PROGRAM <u>EO-1</u>		TITLE <u>CHANGES TO EO-1 SC TO PPT ICD-019</u>					
CCR NO. <u>0020</u>		ORIGINATOR <u>C.Zakrzwski</u>					
DATE INITIATED <u>11/09/98</u>		ORIGINATOR'S CHG. NO. _____					
		SPONSOR/CODE <u>Chuck Zakrzwski</u> PHONE <u>x3392</u>					
EFFECTIVITY  ITEM: <u>EO-1/PPT</u>  S / N _____  ITEM: _____  S / N _____  ITEM: _____  S / N _____		CHANGE CLASS		TYPE OF CHANGE			
		I II		MILESTONE <input type="checkbox"/> INTERFACE <input checked="" type="checkbox"/> SOFTWARE <input type="checkbox"/>			
		PRELIMINARY <input type="checkbox"/> <input type="checkbox"/>		DOCUMENT <input checked="" type="checkbox"/> POWER <input type="checkbox"/> OTHER <input type="checkbox"/>			
		FORMAL <input type="checkbox"/> <input type="checkbox"/>		COST <input type="checkbox"/> WEIGHT <input type="checkbox"/> _____			
		DOCUMENTS OR SOFTWARE AFFECTED <u>EO-1 ICD-019</u>					
PROBLEM  The attached Preliminary Interface Revision Notice (PIRN) contains changes to the Pulsed Plasma Thruster (PPT) Interface Control Document (ICD) 19. This PIRN includes suggested changes that will be incorporated as an Interface revision and will be officially documented as such. The PIRN will become an official

10. Change Figure 3-8 Nominal Operation Load Profile  
From:

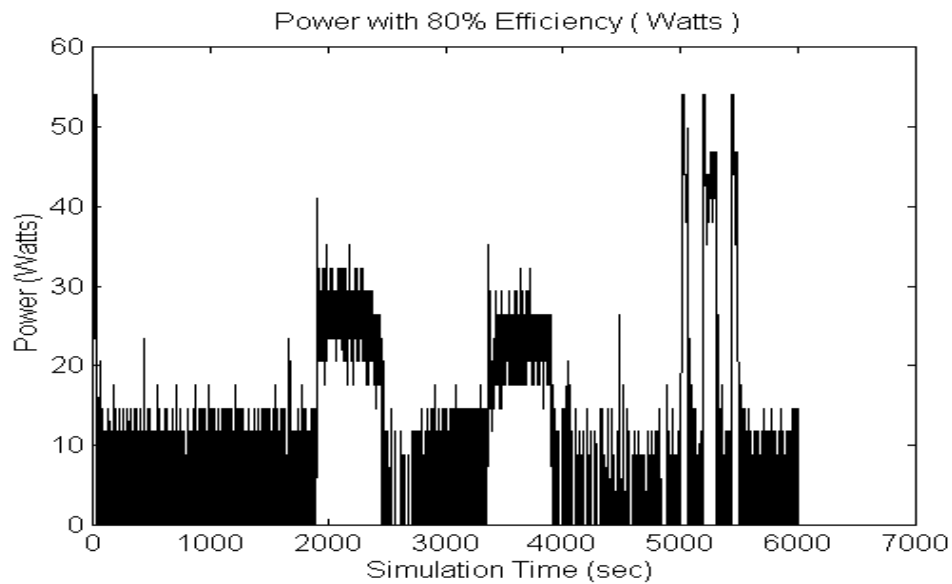
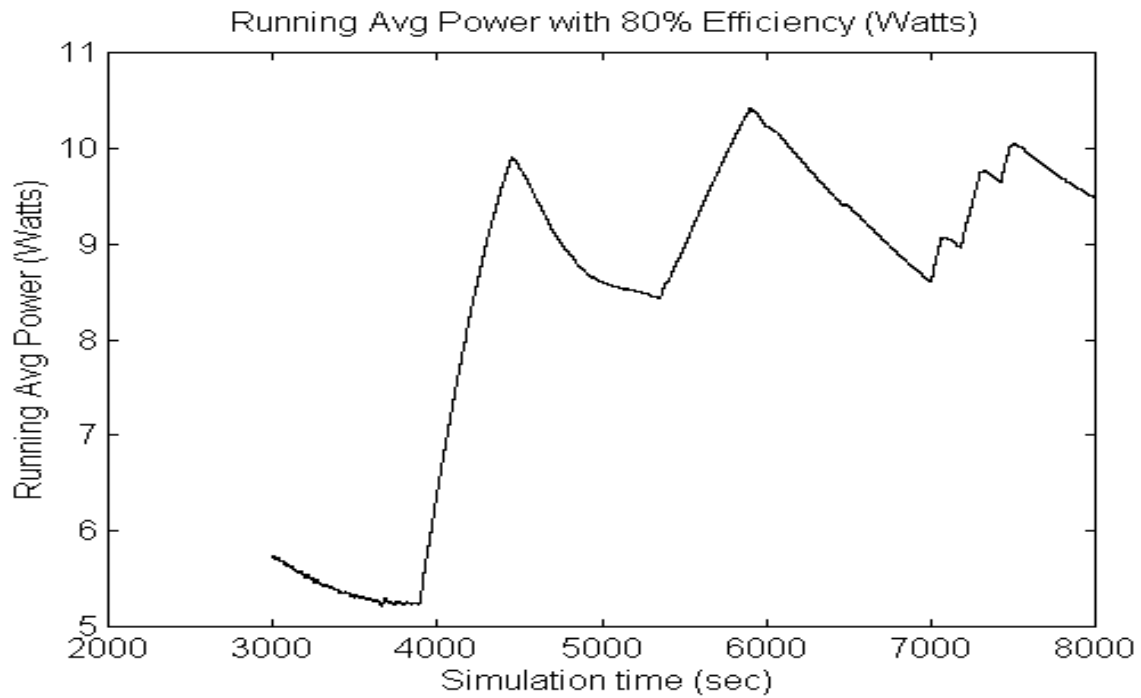
To: Figure 3-8 A

11. Add: The following Figure 3-8 B

**Figure 3.9 Command Pulse Sequence**

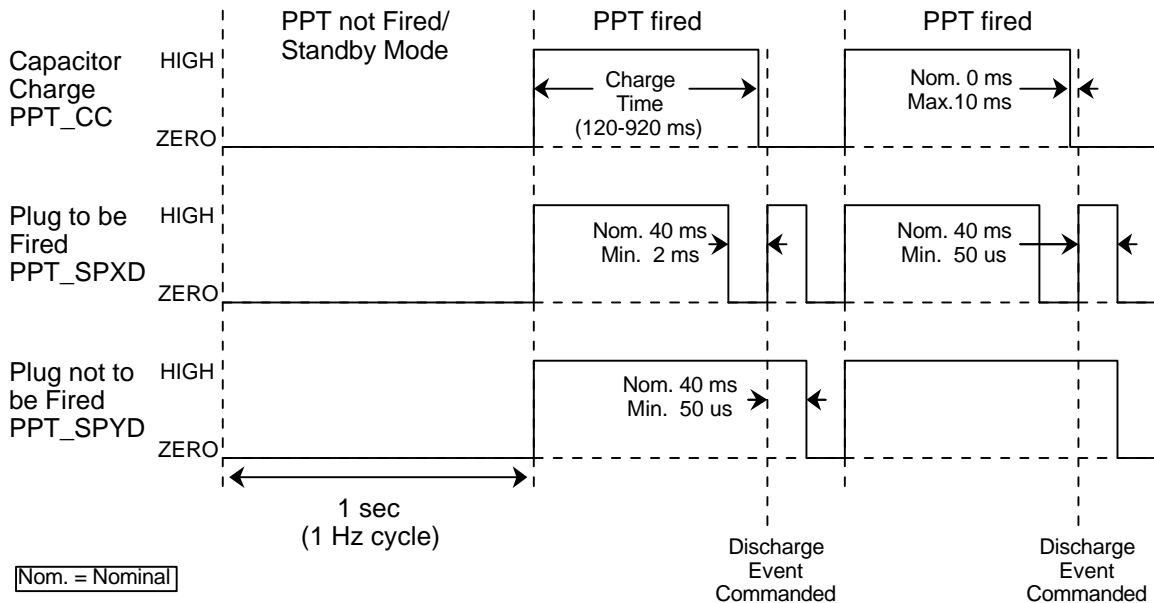
13.Add: The following Figure 3-9 Command Pulse Sequence

To: “The PPT will charge the main capacitor for the length of time the capacitor charge **command** signal is switched from a logic zero to the logic level high position. **per the command sequence constraints shown in the upper trace of Figure 3-9.**”

To: “A spark plug discharge **command** signal will discharge the **selected** spark plug and cause the PPT to fire **within 50 usec of the command transition from logic zero (low) to logic high per the command sequence constraints shown in the middle trace of Figure 3.9.** The spark plug discharge command for the side that is not to be fired will receive the command sequence per the constraints shown in the lower trace of Figure 3.9.”

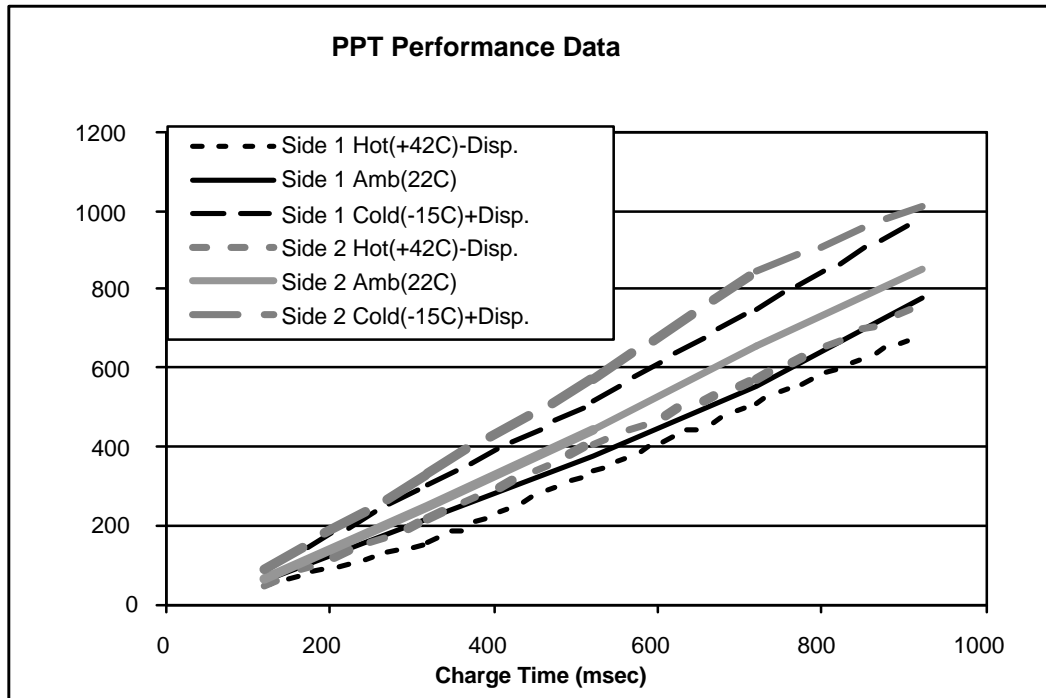
27.Change Section 6.1 Impulse Bits

The nominal impulse bit produced **by each of the two PPT electrodes** as a function of commanded charge time for an input voltage of 28 V is given in **Figure 6-1, the graph below**. The impulse bit varies with temperature for a given charge time. (Note: The temperatures shown are not on-orbit predictions of high, low, and nominal) The added dispersions to the high and low cases shown are half the peak to peak shot-to-shot variations. The graphs are constructed from the data listed in the following table.
